**SUBJECT: PERRY NUCLEAR POWER PLANT, UNIT NO. 1 – CORRECTION TO
AMENDMENT NO. 168 TO FACILITY OPERATING LICENSE CONCERNING
CHANGES TO PRESSURE AND TEMPERATURE CURVES**

CORRECTED PAGES TO LICENSE AMENDMENT NO. 168

Technical Specification pages 3.4-31, 3.4-31a, and 3.4-31b

FIGURE 3.4.11-1(a): PRESSURE TEST CURVES (VALID UP TO 32 EFPY)

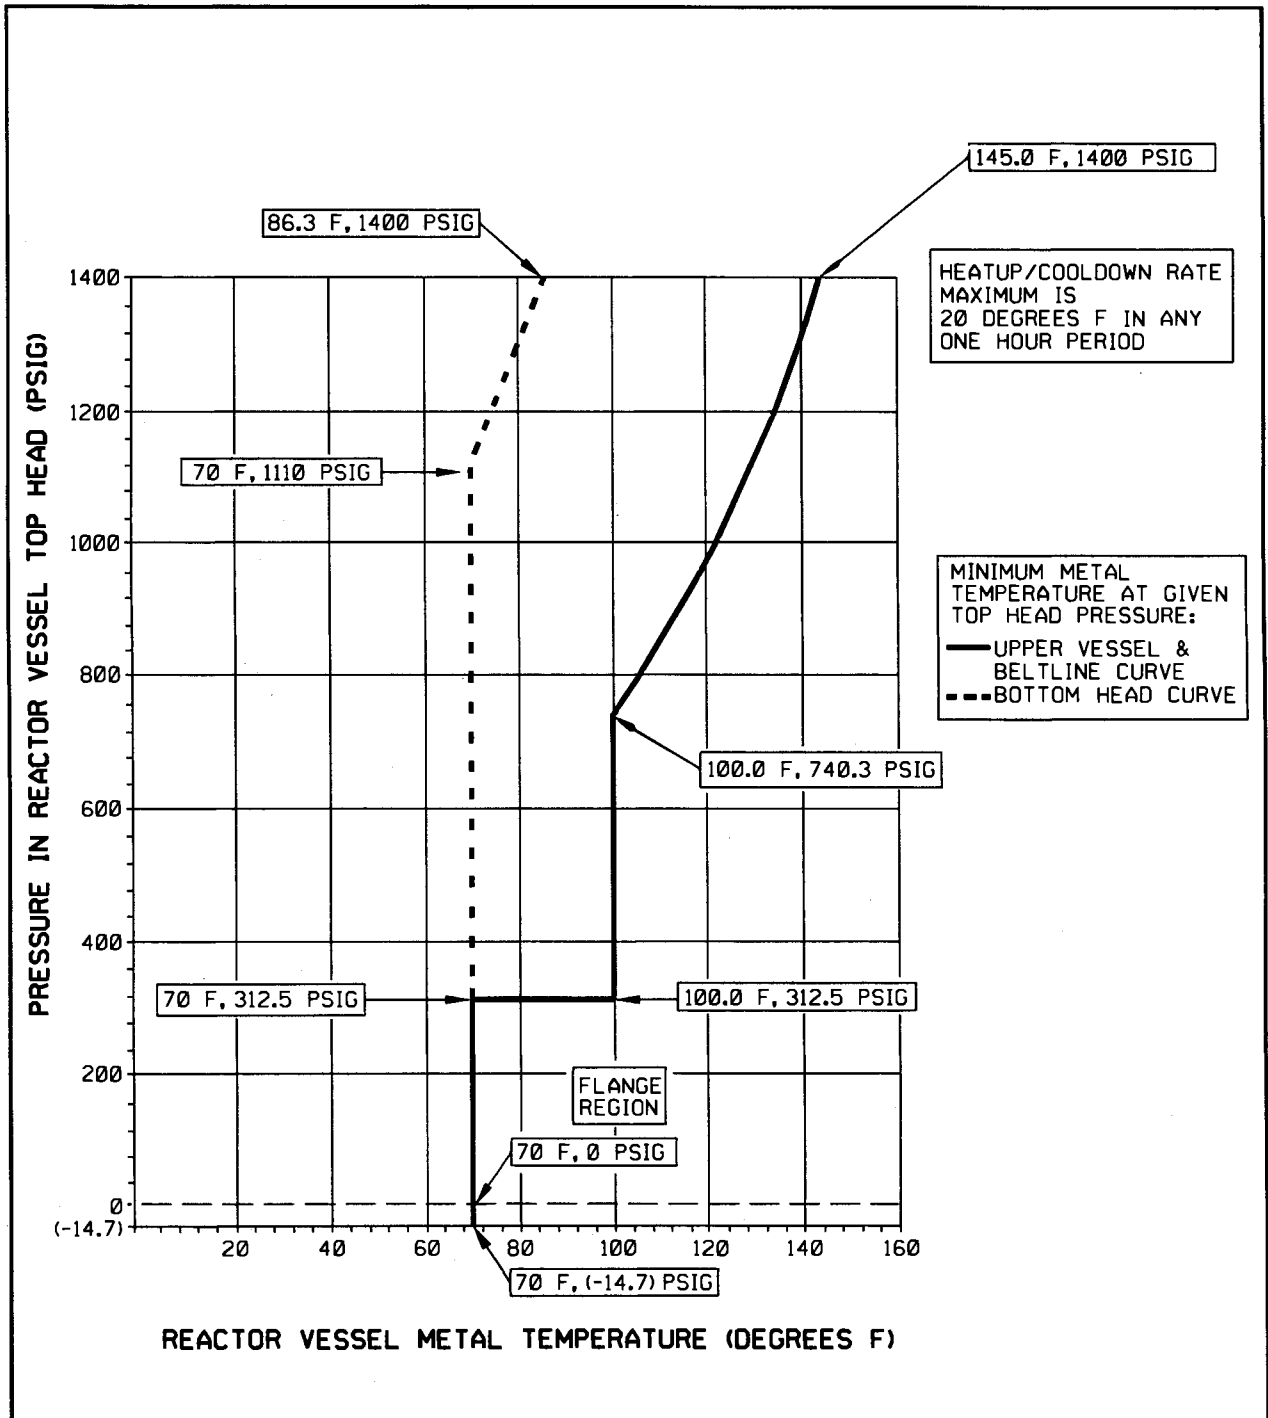
On January 15, 2019, the NRC staff identified an error on Technical Specification (TS) pages 3.4.-31, 3.4-31a, and 3.4-31b issued with Amendment No. 168. Specifically, on each pressure and temperature figure (Figures 3.4.11-1(a), 3.4.11-1(b), and 3.4.11-1(c)), the note box regarding the heatup/cooldown rate specified the rate as a temperature per hour. However, the license amendment request, dated June 23, 2014, specified the heatup/cooldown rate as a temperature limit "in any one hour period."

The NRC staff concludes that the error was inadvertently introduced during the preparation of the license amendment and is editorial in nature. The correction does not change any of the conclusions in the safety evaluation associated with the amendment and does not affect the associated notice to the public. Enclosed, please find the corrected replacement TS pages.
